Town of Rolesville
Planning Review
502 Southtown Circle
P.O. Box 250
Rolesville, North Carolina 27571

RE: The Point – Phase 10
Case Number: FSP-25-01
Response to 1st F5 Plat Review Comments
AWH20000

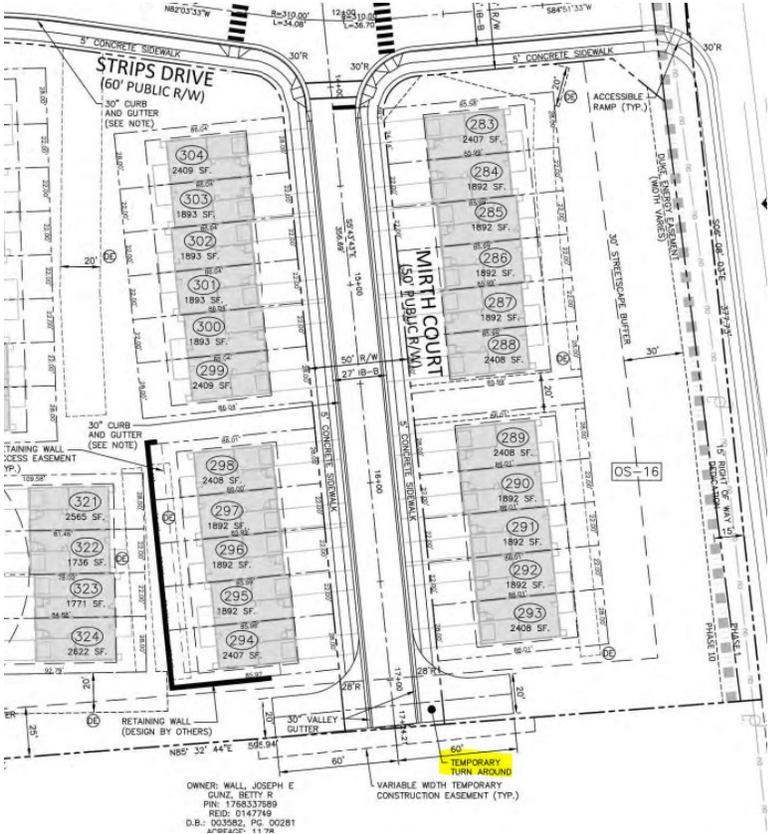
1. Staff contacted Katie and J. Taylor from McAdams to try to broach the below – please address this in the response to comments:

Is there a temporary turnaround noted at the dead end of Mirth Court? Or will it connect to an existing street?

McAdams Response: Yes, see snippet below.

FINAL PLAT SHEET 3-5

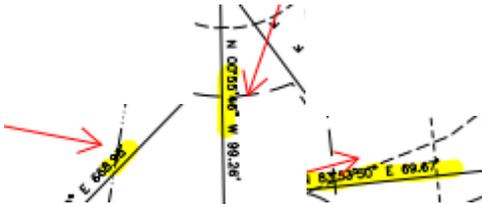
- 2. Provide grid coordinated or grid tie. Provide reference or statement of how the coordinates were derived. (Does not have to be at this specific point).

McAdams Response: Grid coordinates added.
